BURLINGTON DEVELOPMENT REVIEW BOARD

Wednesday November 5, 2014

TO: Development Review Board
FROM: Ken Lerner
DATE: October 21, 2014
RE: 15-0397CA, 1127 North Avenue

Request: Construct new single story building addition to existing hardware store for retail space.

PARKING GARAGE AND CANOPY LUMINAIRE

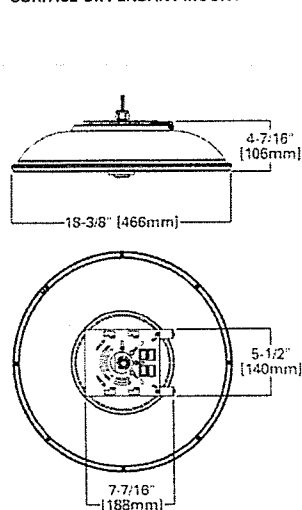
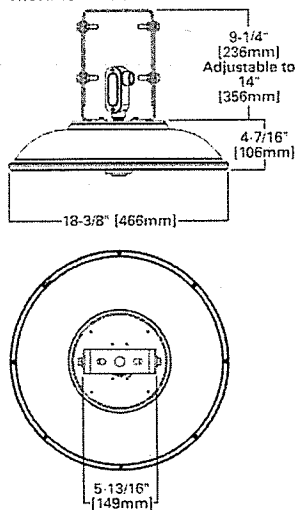
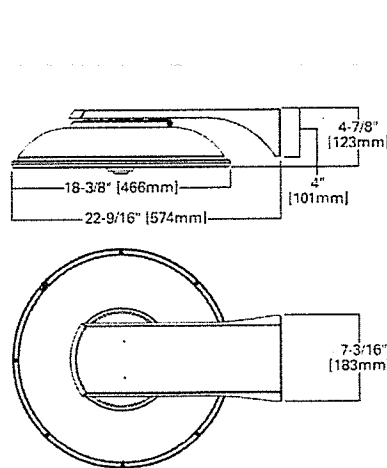
New outdoor lighting will be under the canopy. Acceptable LED cutoff fixtures are proposed. **(Affirmative finding)**

DATE 12-01-2011	REVISION 1	PROJECT ETHAN ALLEN SHOPPING CENTER PROPOSED ACE HARDWARE ADDITION NORTH AVENUE - DURLINGTON	SHEET 1
O'LEARY-BURKE CIVIL ASSOCIATES, PLC		OVERALL PLAN

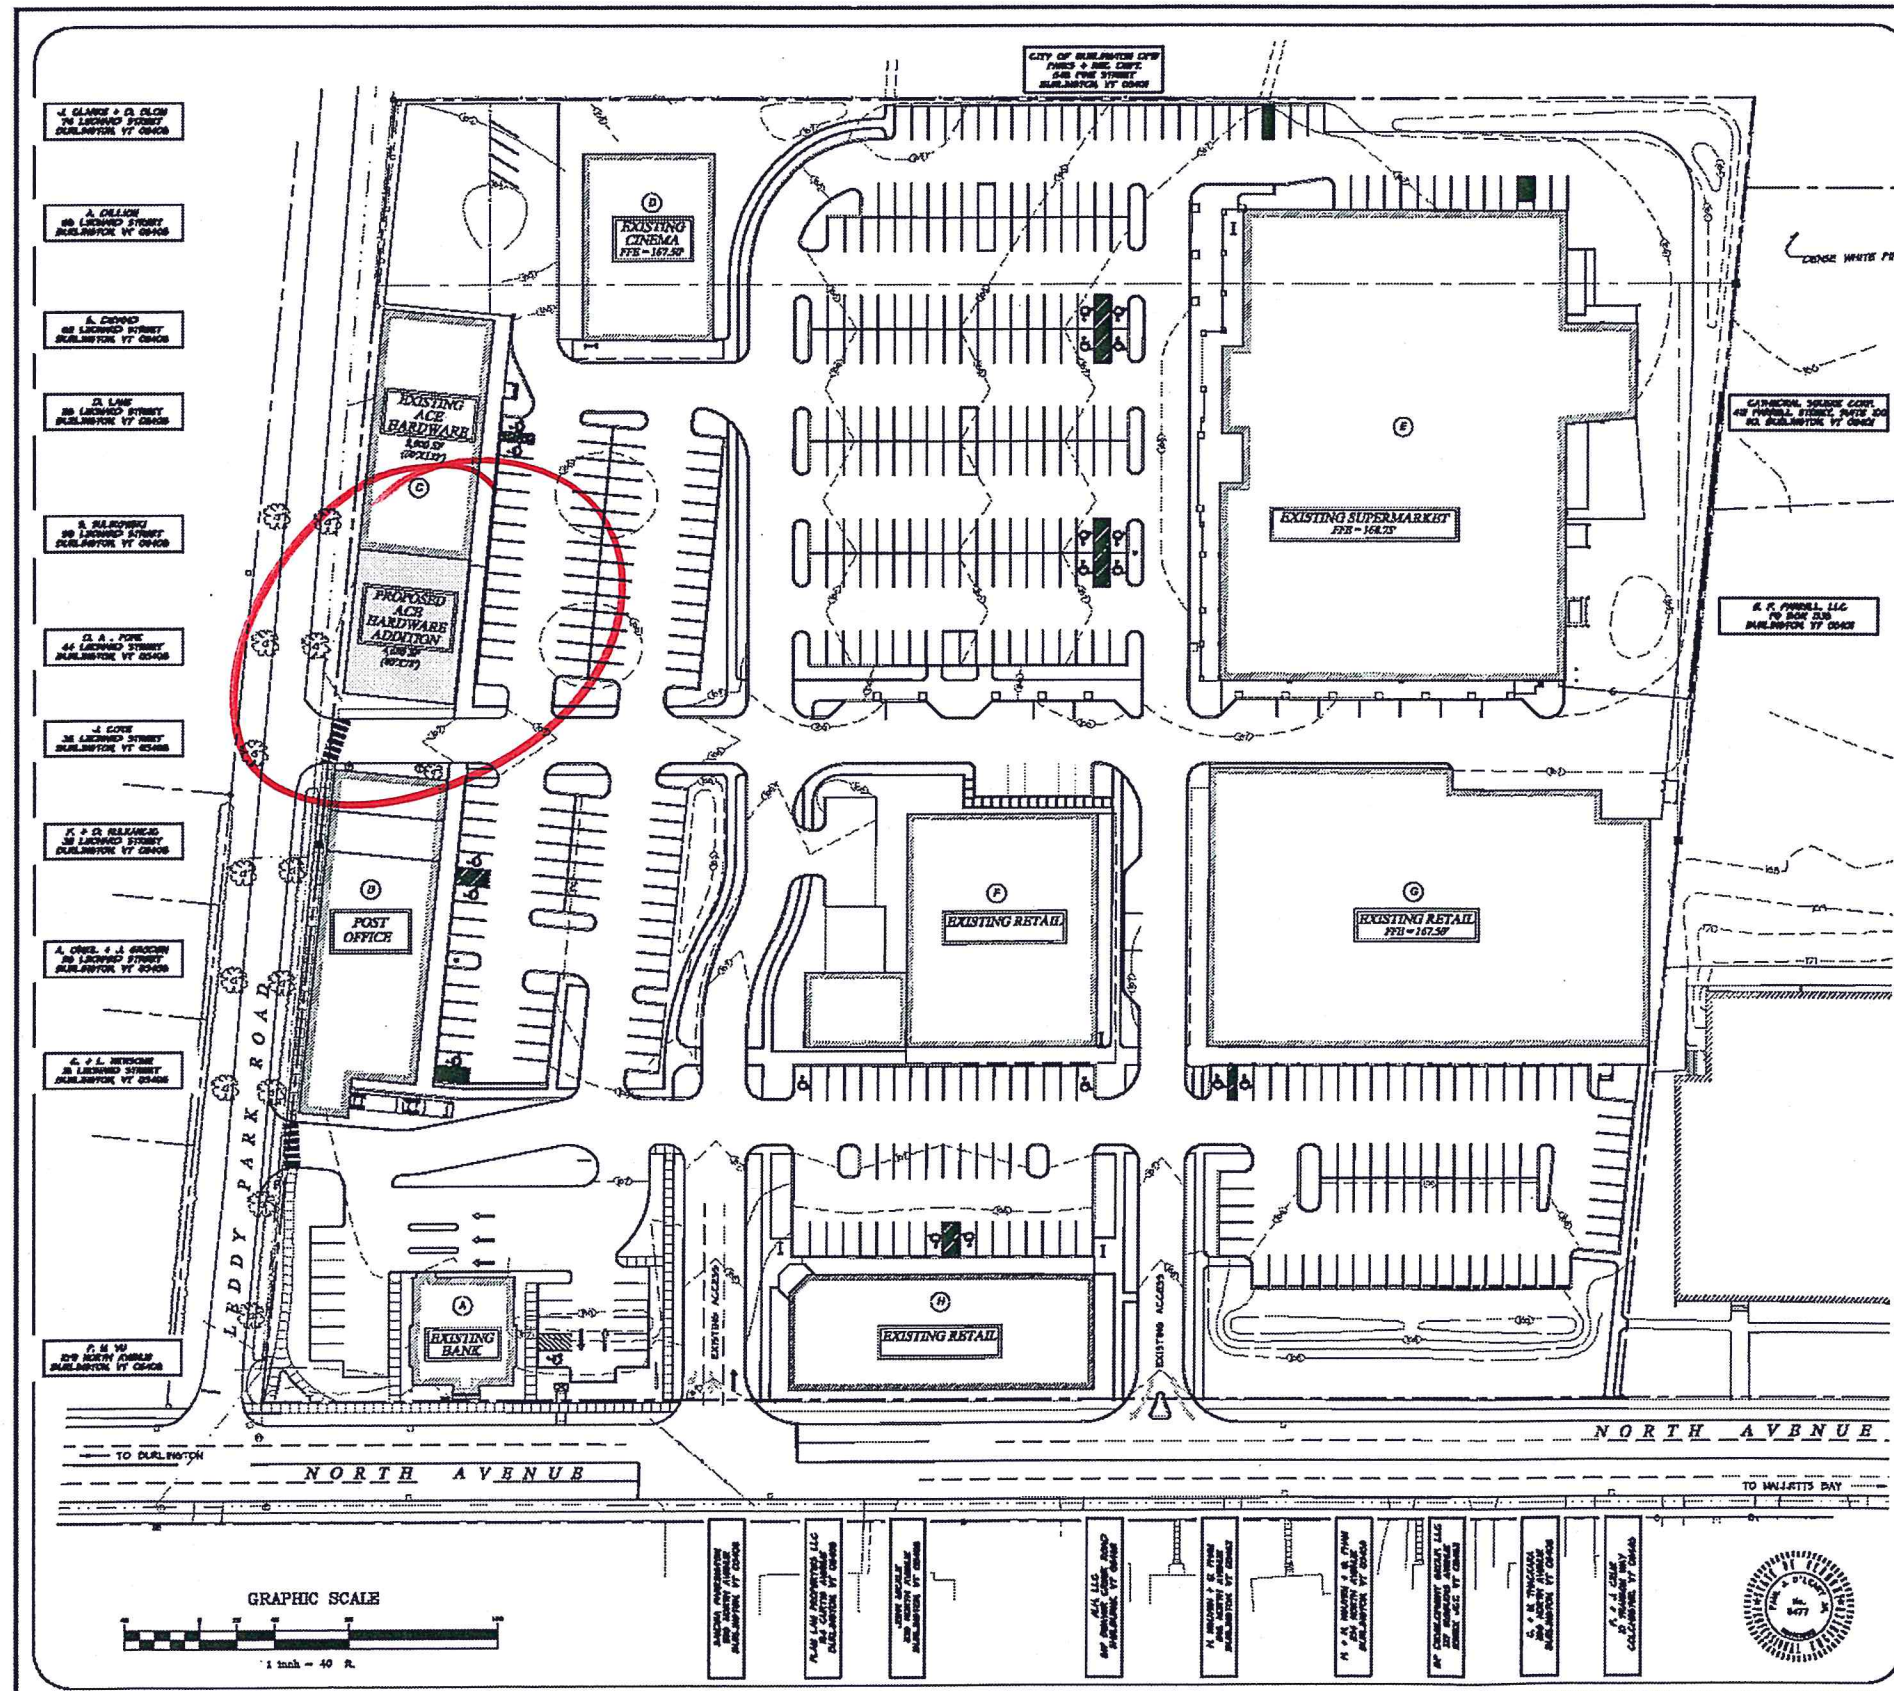
Lot coverage will increase from 78.9% to 79.8% based on the site plan provided and stamped by the project engineer. This is below the maximum allowable 80% coverage.

The property has two front yards – North Avenue and Leddy Park Road. The required front yard setback is 12 feet from the street frontage curb. While there is no curb on Leddy Park Road, the new addition's closest point is 20 feet from the paved roadway on Leddy Park Road. Side yard setbacks are not applicable in the NAC zone, the side yards for the subject site are Leddy Park to the west and

Original Parking Required	Current Parking Required
General retail existing COA 00-031	746 x 40% waiver = 299	224
Proposed Addition 4,320 sf	NA	9
Total Required		233

Thus, adding the new requirement of 9 spaces, results in a total parking requirement of 233 spaces; this is below the calculated 299 spaces that were provided under COA 00-031 approved for the renovated shopping center. **(Affirmative finding)**

PROPOSED NORTH ELEVATION
3/16" = 1'-0"

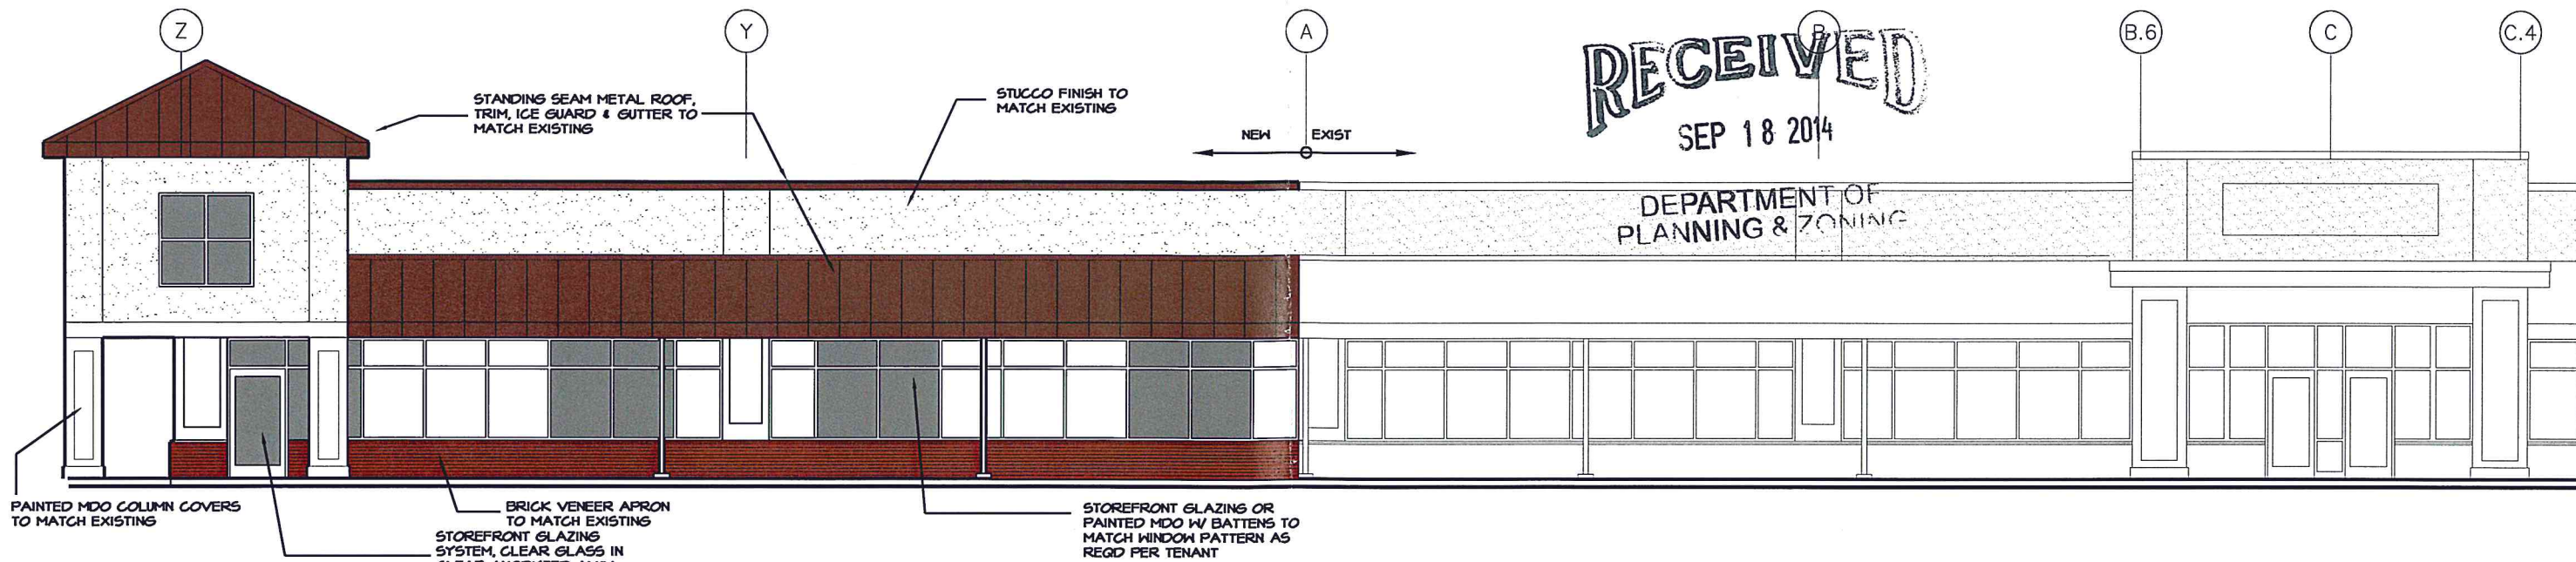
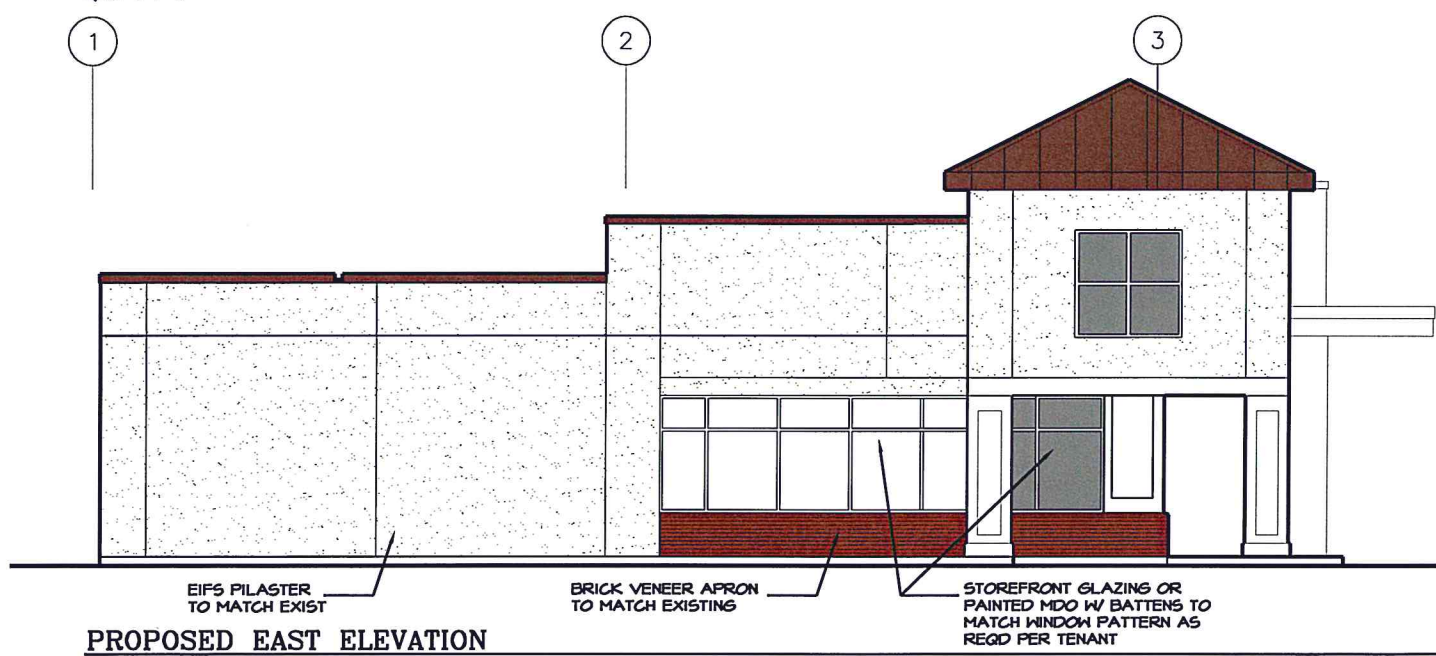
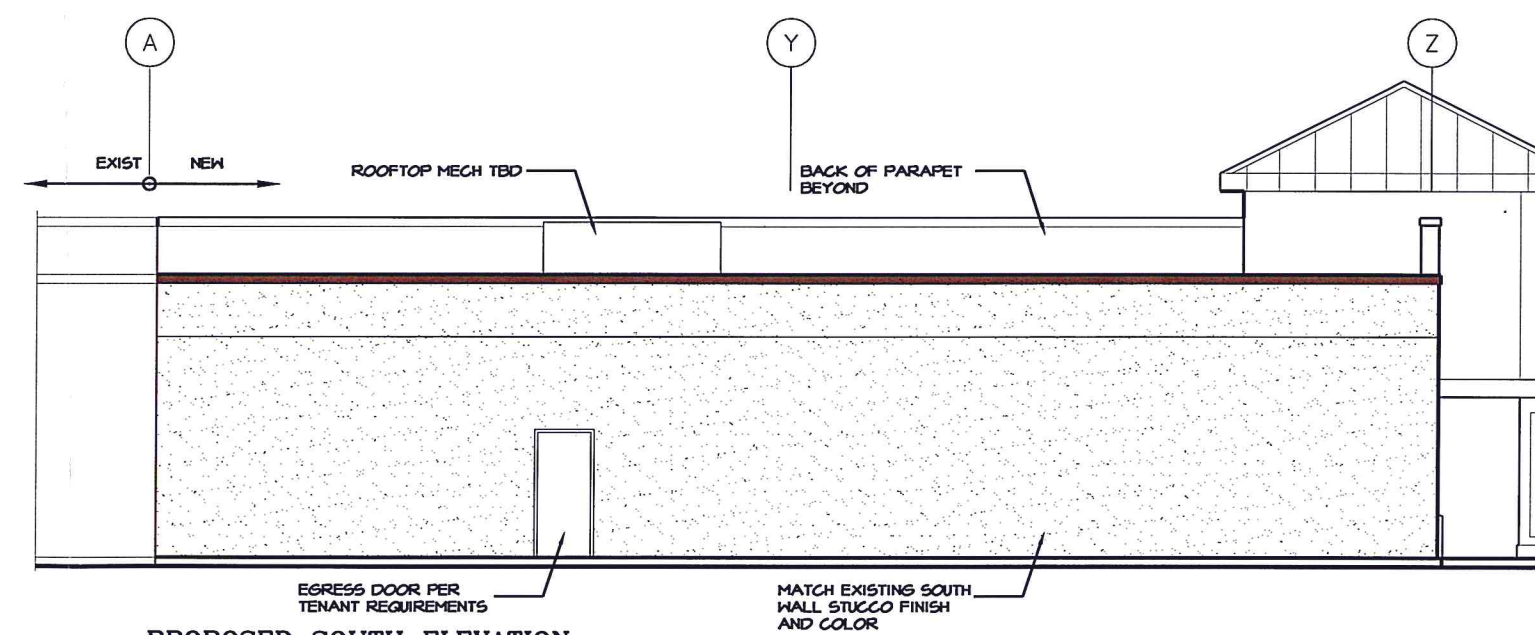
Overall building height will match the existing building at 19.5 feet high and includes a tower element at the eastern & north corner that is 27.5 feet to the peak; under the maximum permissible 35' height.

The proposed addition continues the roof line of the existing. **(Affirmative finding)**

Building opening is at the east end under the overhang of a taller element at the corner. Nearly 50% of the building front and exposed (east) side include storefront glazing typically found in the shopping center. **(Affirmative finding)**

A metal roof and stucco siding with a brick base is proposed to be consistent with the existing building and are appropriate for this commercial building. **(Affirmative finding)**
